Industrial Estate at Lot 210 DP1174939 (Stage 3), Tomago

Stormwater Management Plan

Northbank Enterprise Hub
1918-02-B13, 14 March 2025

Fig 4.1, Stage 3 SWMP
(refer to attached **Plan 1**)

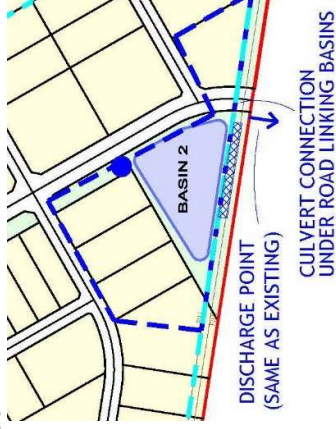
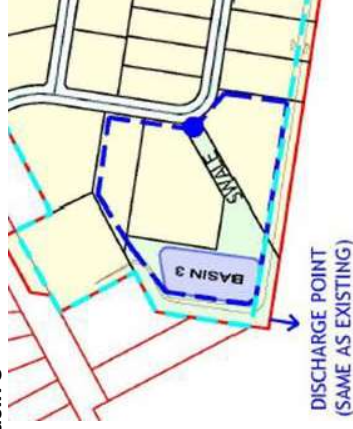
| # | Subject | DPHI or other agency feedback | NEH response |
|---|-----------------|---|--|
| 1. | Discharge point | <p>The Stage 3 SWMP is proposing an additional point of discharge from the site which was not contemplated as part of the original assessment and it is unclear whether this is a legal point of discharge.</p> | <p>Northbank Enterprise Hub Pty Limited (NEH) has considered Department of Planning, Housing & Infrastructure (DPHI)'s feedback and the additional discharge point has been removed from the Stage 3 Soil & Water Management Plan (Stage 3 SWMP).</p> <p>Relevantly, Condition 2 of Schedule 2 of the NSW Major Project Approval MP07_0086 (Project Consent) requires NEH to carry out the development generally in accordance with a number of documents, including the Environmental Assessment (EA) (as defined in the Project Consent).</p> <p>Section 3.4 (Stormwater Controls/Site Design) in Volume 4 of the EA states:</p> <p style="margin-left: 40px;">3.4.3 Discharge <i>From Figure 2, there are three (3) existing discharge points from the site along the southern boundary. These are open channel farm drains continuing downstream of the site toward the Hunter River. Basins have been suitably located to have discharge outlets to these existing discharge points from the site, post development. Refer to Figure 6.</i></p> <p>For reference, we extract Figure 4.1 in the Stage 3 SWMP below (refer to attached Plan 1) and Figure 6 in the EA (refer to attached Plan 2) below. Figure 4.1 in the Stage 3 SWMP shows a plan that is consistent with the number of discharge points at the same locations as required under the Project Consent. This confirms 2 of the discharge points to be consistent. The third discharge point referenced is for Stage 1, to the east and not relevant to the Stage 3 SWMP.</p> |

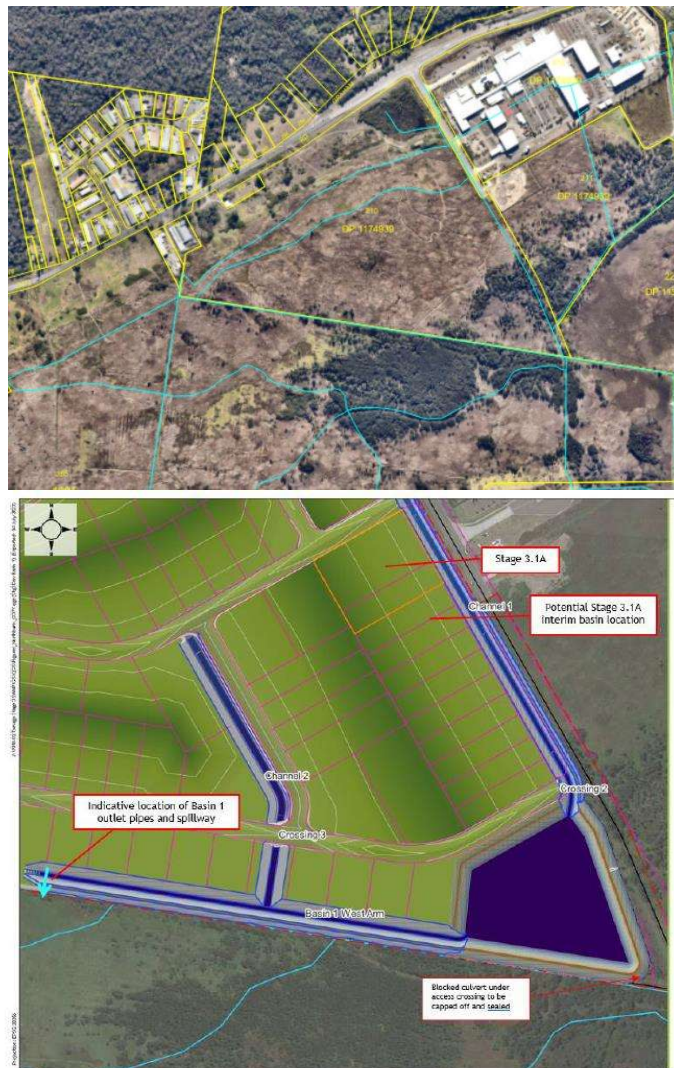
It is unclear where the Legal Discharge Points for stormwater are and whether downstream infrastructure is adequate to convey flows. Basin 1 and Basin 2 appear to be discharging water to the downstream property without any legal right. Additionally, there does not appear to be any existing downstream channel to convey the concentrated stormwater discharging from the development. As such, there is concern that discharging stormwater onto downstream property Lot 1001, DP 1127788 without any defined flowpath would facilitate erosion, frequent flooding of the property, and potentially reducing usable land. As such, it is recommended that a drainage system within downstream property be designed and constructed to discharge the water.

It is still unclear what impact the discharging of concentrated water will have on downstream. It is recommended further details be provided on this now instead of at construction stage. The concerns are:

Figure 6.4 - Approved drainage strategy for proposed development at Lot 1001 (Project Approval MP10_0185)

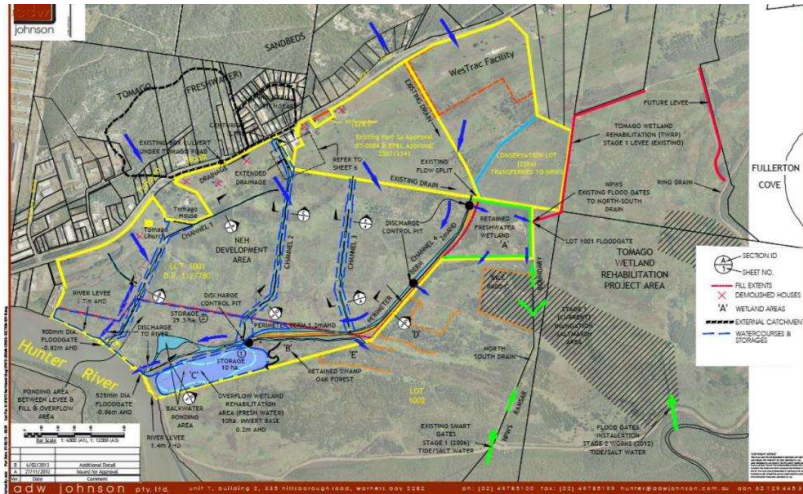
- The following item was requested to be addressed in previous RFI:

The plan below indicates that there will be channels constructed at the discharge points of basin 1 and basin 2 but, there is no details provided in the report.

No details have been provided to address this. It is recommended that details be provided to certifier prior to construction approvals being issued.

Figure 6.4 - Approved drainage strategy for proposed development at Lot 1001 (Project Approval MP10_0185)

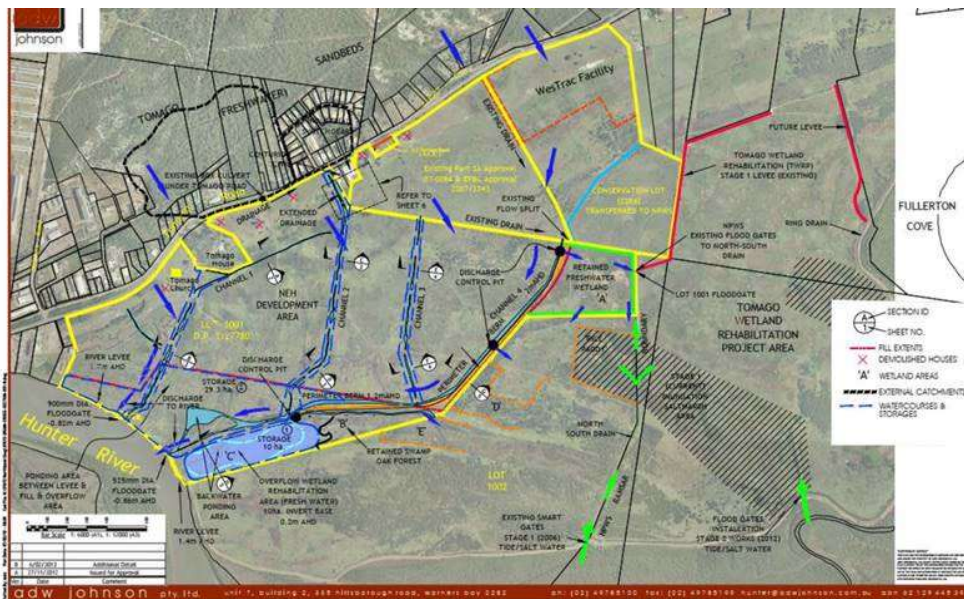
2. Freeboard for the basins are shown as; basin 1 - 240mm and basin 2 - 410mm. A minimum 500mm freeboard is required for all basins.
3. It is unclear where the Legal Discharge Points for stormwater are and whether downstream infrastructure is adequate to convey flows. Basin1 and Basin 2 appear to be discharging water to the downstream property without any legal right. Additionally, there doesn't appear to be any existing downstream channel to convey the concentrated stormwater discharging from the development. As such there is concern that discharging stormwater onto downstream property Lot 1001, DP 1127788 without any defined flowpath would facilitate erosion, frequent flooding of the property, and potentially reducing usable land. As such it is recommended that a drainage system within downstream property be designed and constructed to discharge the water in a controlled manner with legal rights to do so put in place.

4. While it is noted the overall Stormwater management strategy report is good, the report does not address the impact of the development on downstream properties including:
 - dramatically increased volume of water,
 - displacement of water as a result of filling the land,
 - frequencies of flooding,
 - legal discharge point,
 - requirement for a downstream channel etc.
5. The plan below indicates that there will be channels constructed at the discharge points of basin 1 and basin 2 but, there is no details provided in the report.

Figure 6.4 - Approved drainage strategy for proposed development at Lot 1001 (Project Approval MP10_0185)

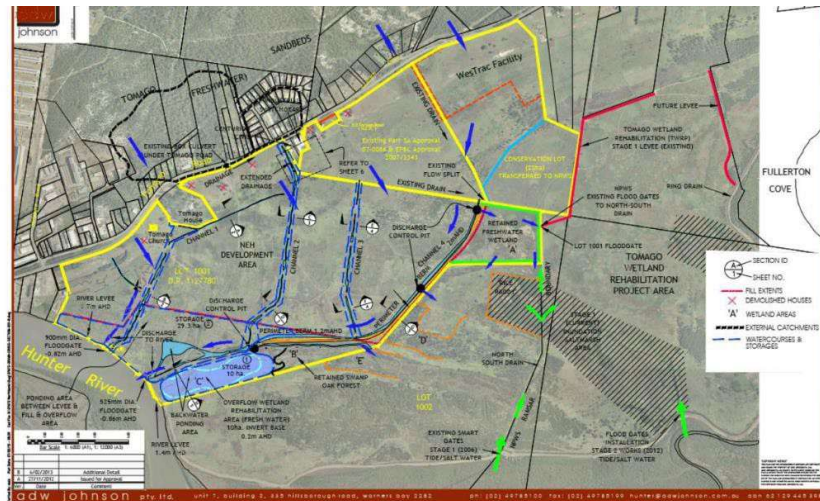
- The following item was requested to be addressed in previous RFI:

The plan below indicates that there will be channels constructed at the discharge points of basin 1 and basin 2 but, there is no details provided in the report.

No details have been provided to address this. It is recommended that details be provided to certifier prior to construction approvals being issued.
